Charlotte Historic District Commission Staff Review HDC 2016-297

PROPERTY ADDRESS: 1610 Dilworth Road East

SUMMARY OF REQUEST: New window

FRONT ELEVATION: EXISTING / DEMO and PROPOSED

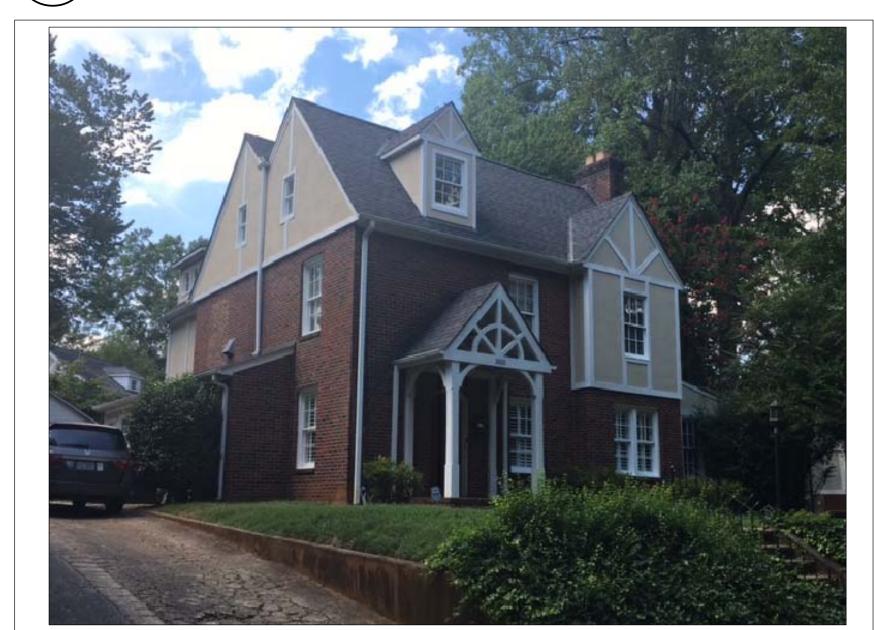
The project is the installation of a fixed window in the front gable with trim to match existing in material and dimension.

The Commission shall determine if the window design meets the applicable guidelines, items 4 and 5.
